ADDENDUM NO. 02
To Drawings and Specifications dated 02/07/24

Date: FEBRUARY 7, 2024

PROJECT: **Warner Middle School HVAC Upgrade & Modernization**
A#04-121954
Westminster School District

23 FLOOR PLAN - BUILDING C3
3/32" = 1'-0"

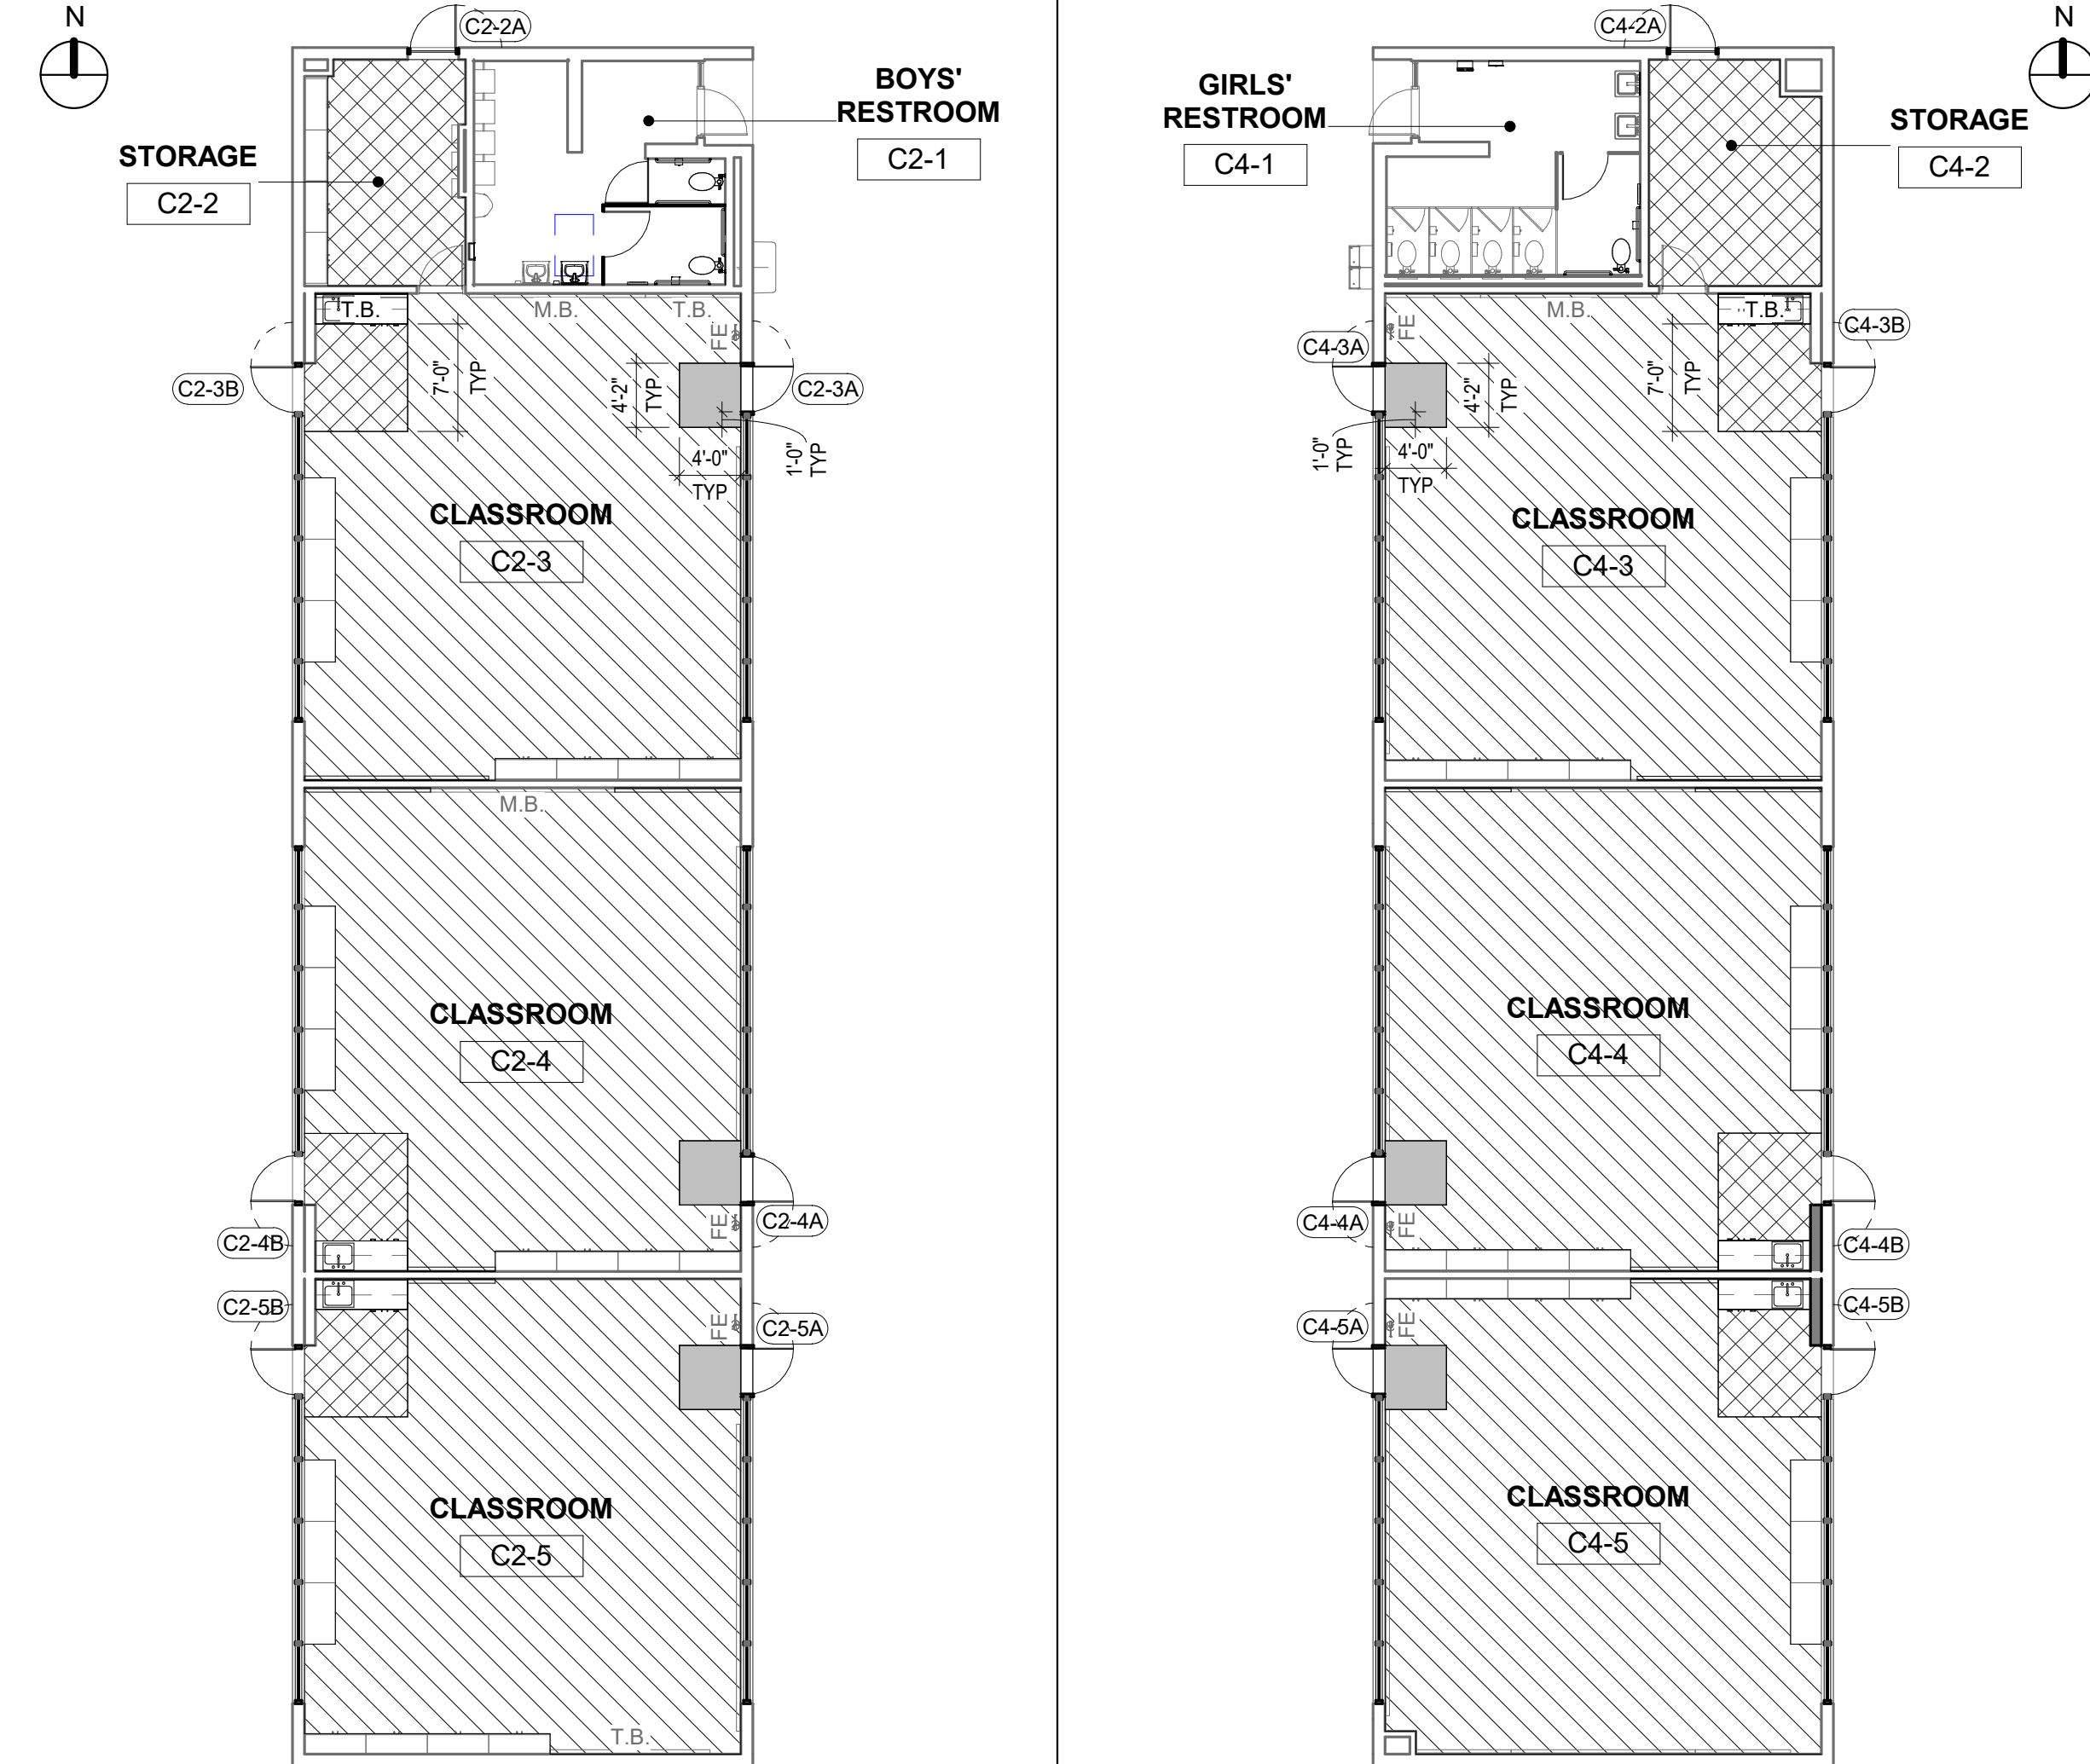
11. Detail “23 – Floor Plan – BUILDING C3”
 - a. Added “LVT” to classroom C3-3, C3-4 & C3-5.

17 FLOOR PLAN - BUILDING C5
3/32" = 1'-0"

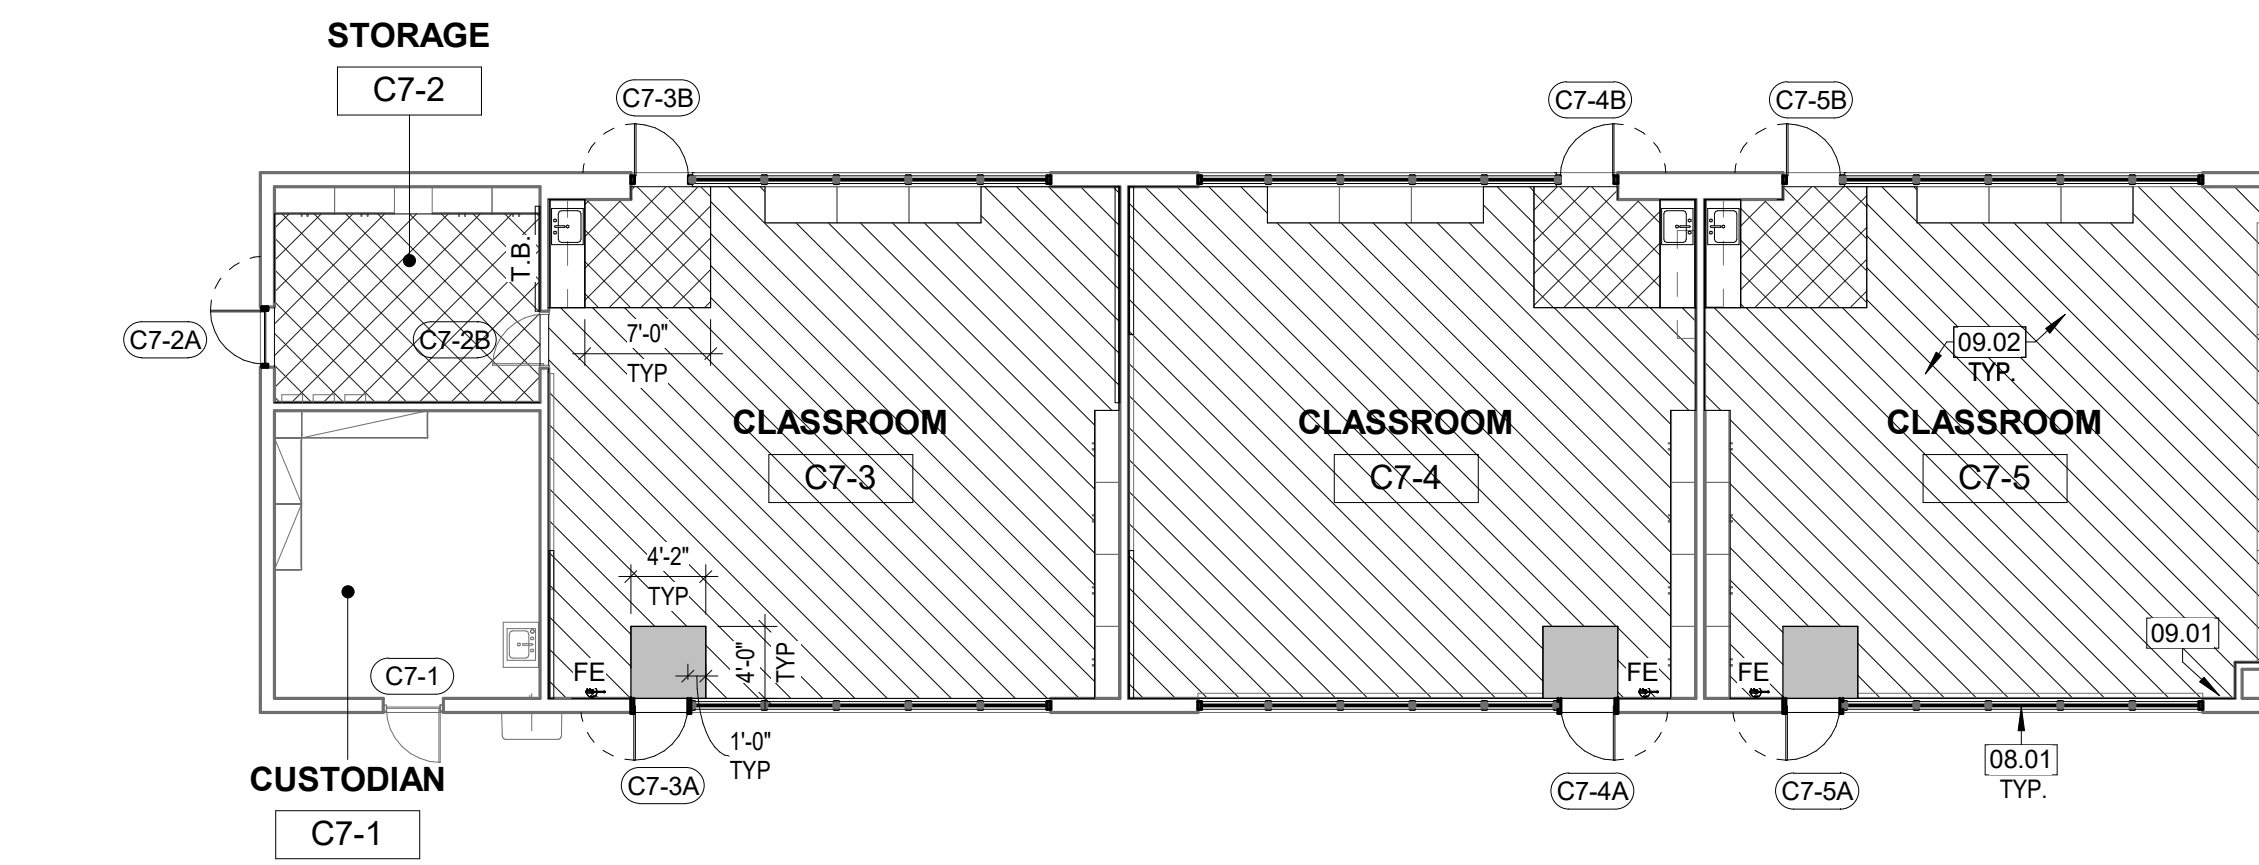
9. Detail “14 – Floor Plan – BUILDING C7”
 - a. Added “LVT” to classroom C7-3, C7-4 & C7-5.
10. Detail “17 – Floor Plan – BUILDING C5”
 - a. Added “LVT” to classroom C5-3, C5-4 & C5-5.

3 FLOOR PLAN - ADMINISTRATION BLDG
1/8" = 1'-0"

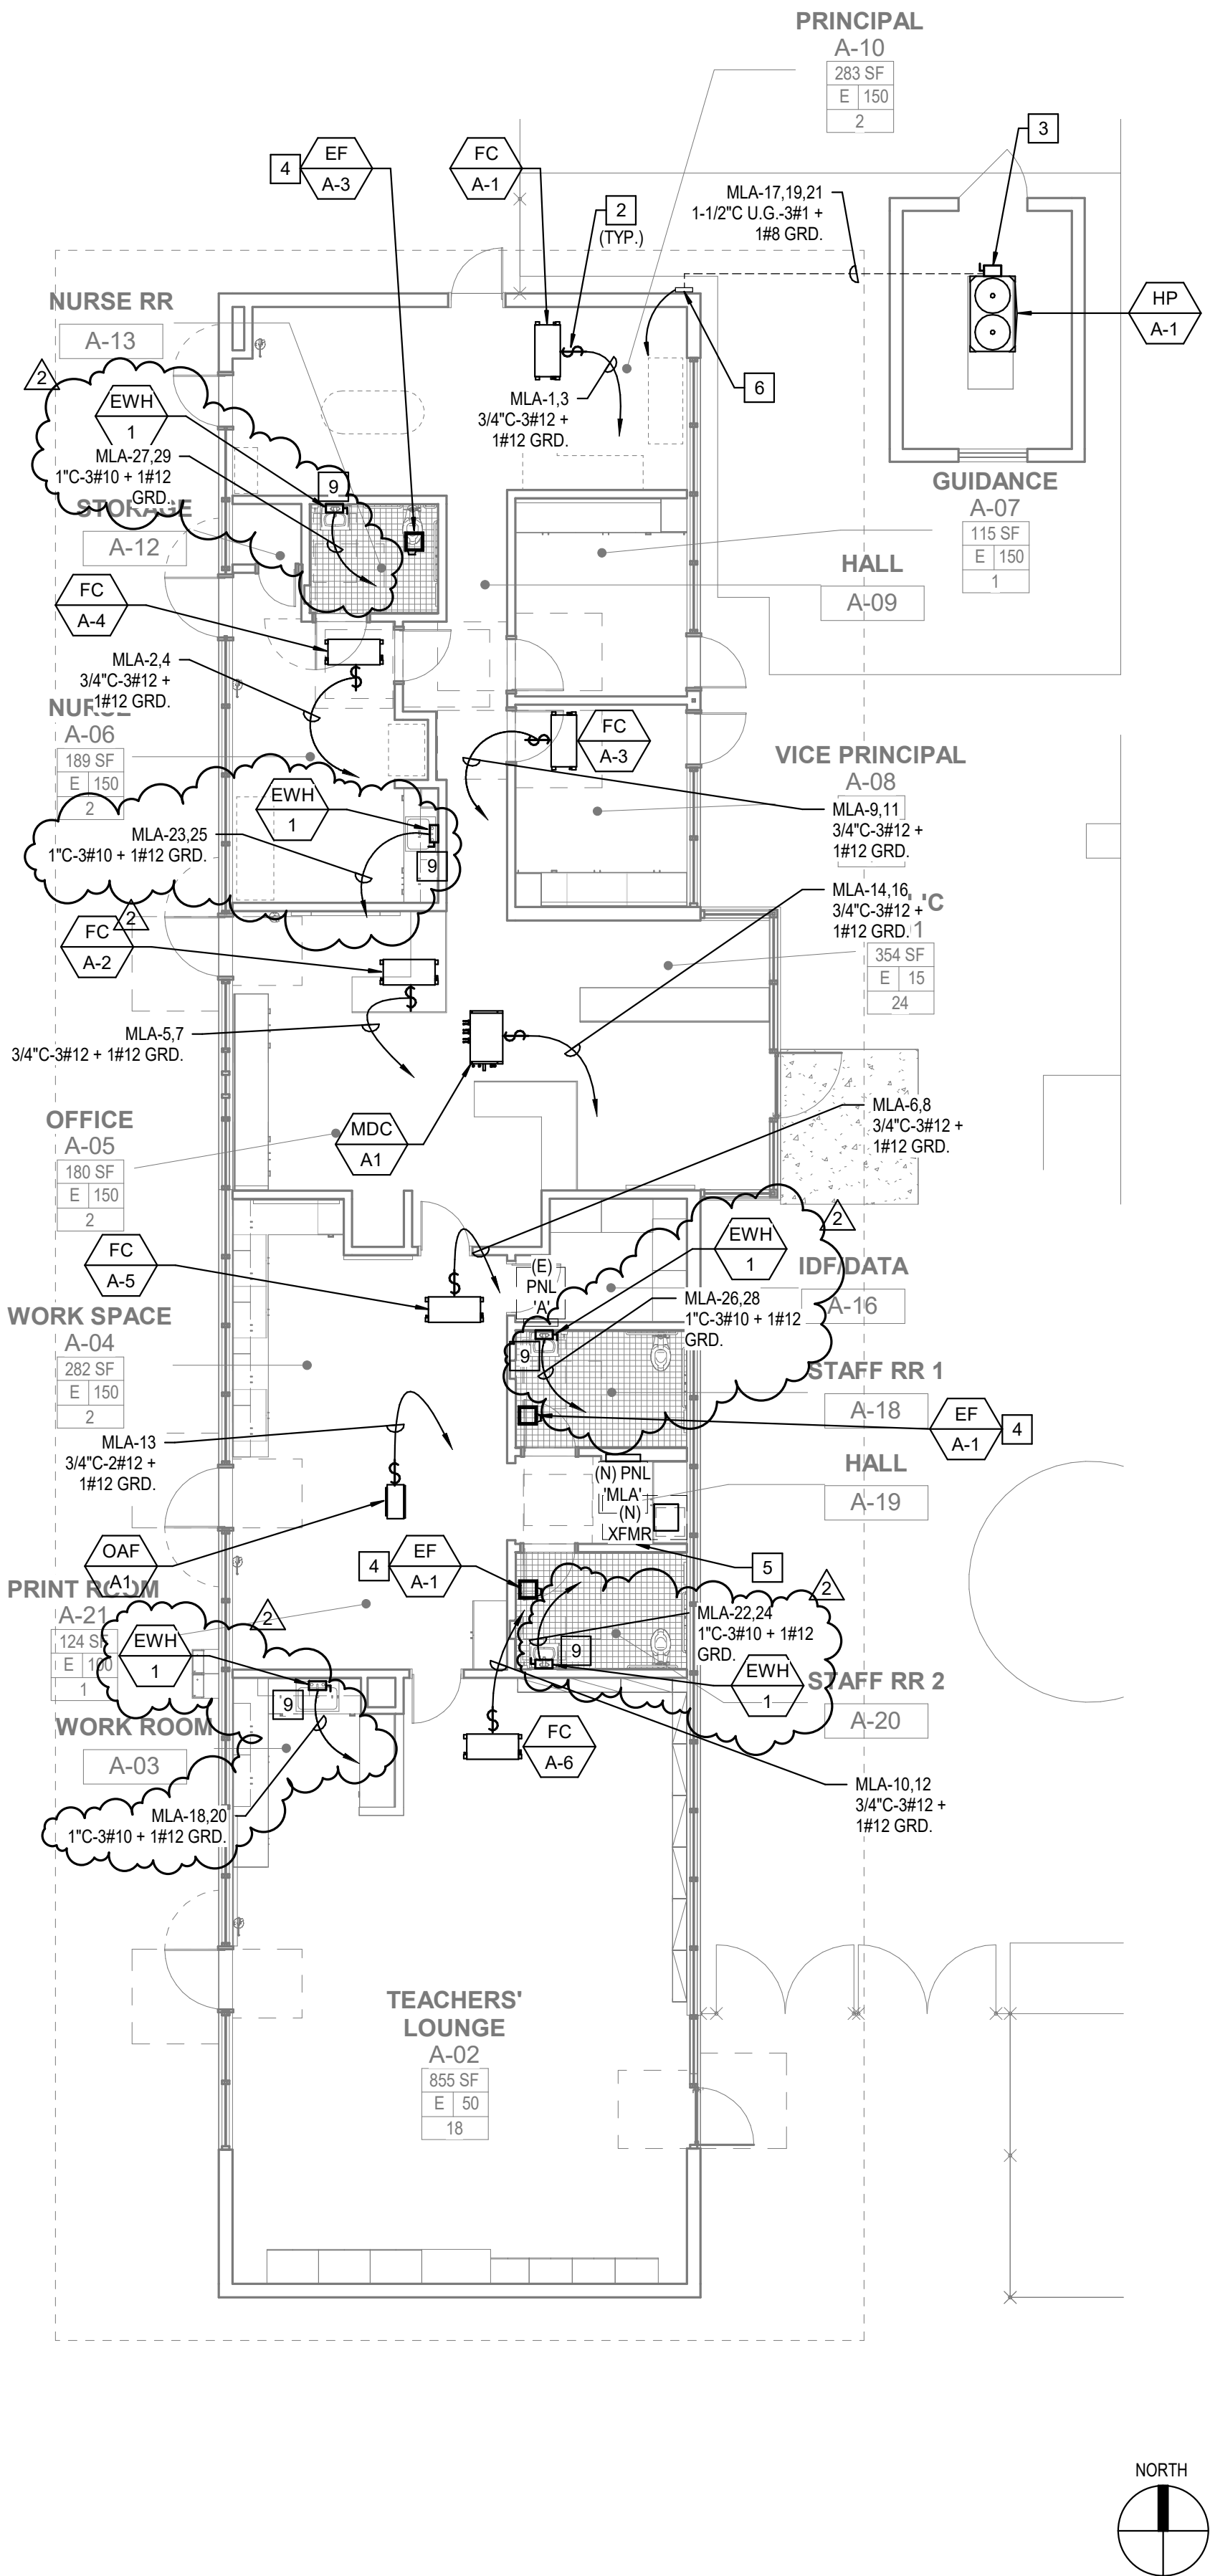
1. Detail 3 – Admin. Bldg.
 - a. Added power for Electric Water Heaters 'EWH-1'
 - b. Added keynote # 9 for water heaters.
2. Detail 2 – Bldg. S-L
 - a. Added power for Electric Water Heater 'EWH-1'
 - b. Added keynote # 9 for water heaters.
